SUNDRY NOTICES AND REPORTS ON WELLS

8. Well Name and No.
RINGER FEDERAL COM 119. API Well No.
30-015-40738-00-X110. Field and Pool, or Exploratory
SAGE DRAW11. County or Parish, and State
EDDY COUNTY, NM

THE PERMIT FOR THIS WELL IS DUE TO EXPIRE SEPT. 19, 2014. CIMAREX RESPECTFULLY REQUESTS A PERMIT EXTENSION DUE TO RIG SCHEDULING.

PECOS DISTRICT CONDITIONS OF APPROVAL

Cross Section of a Typical Lead-off Ditch

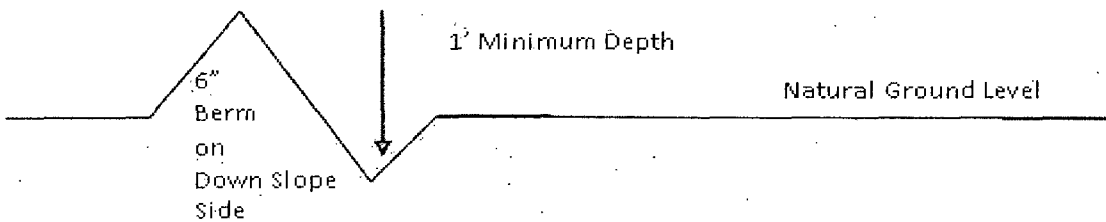
A typical lead-off ditch has a minimum depth of 1 foot below and a berm of 6 inches above natural ground level. The berm shall be on the down-slope side of the lead-off ditch.

Figure 1 – Cross Sections and Plans For Typical Road Sections

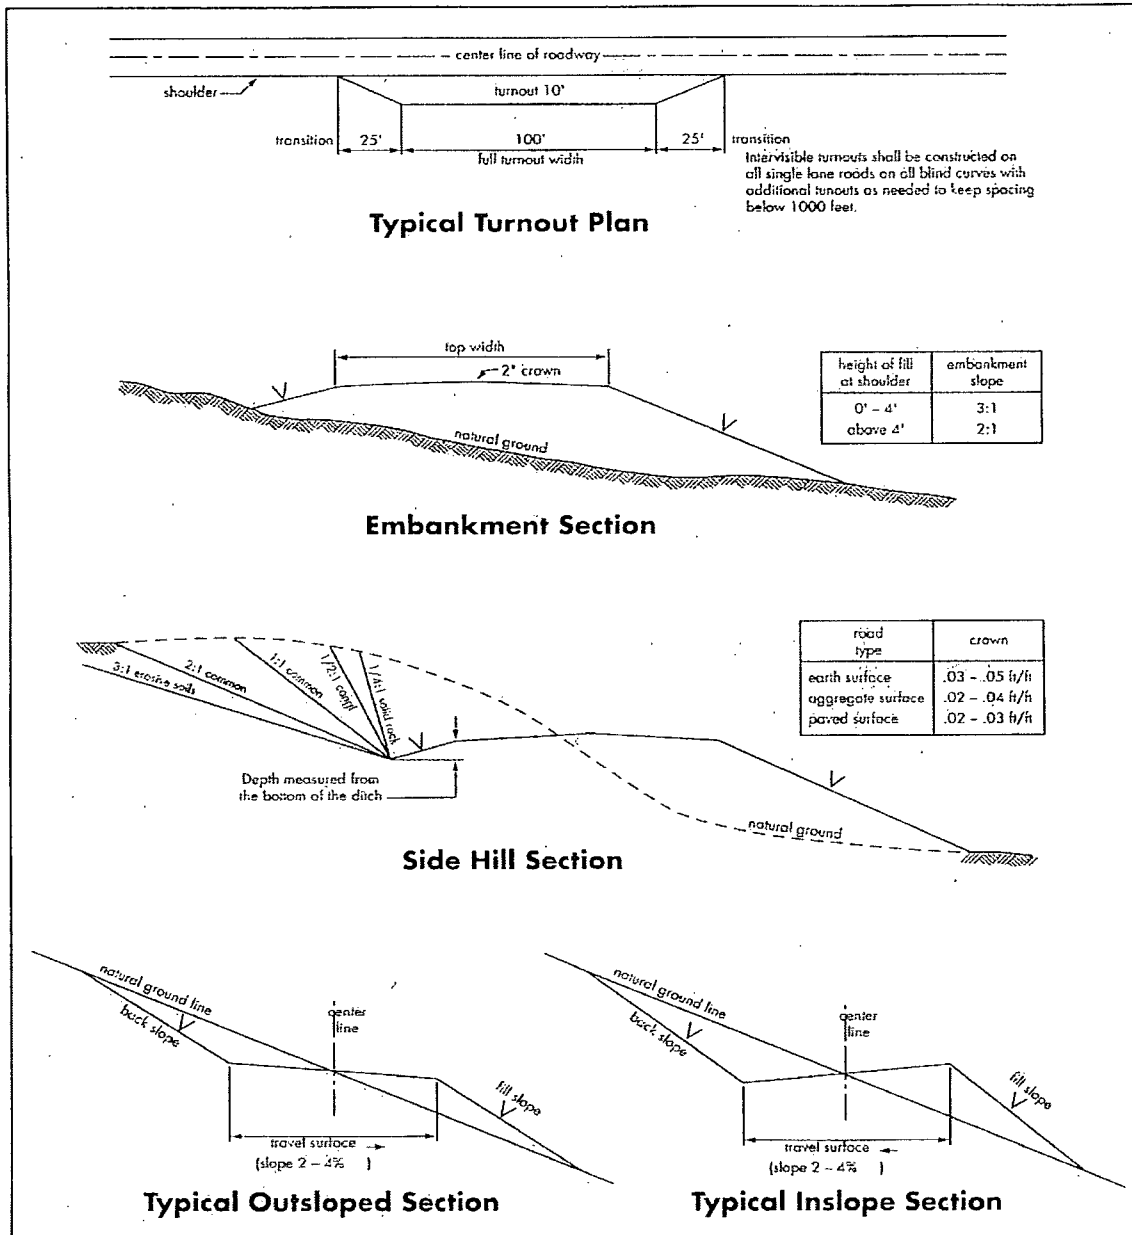
Crowning shall be done on the access road driving surface. The road crown shall have a grade of approximately 2% (i.e., a 1" crown on a 14' wide road). The road shall conform to Figure 1; cross section and plans for typical road construction.
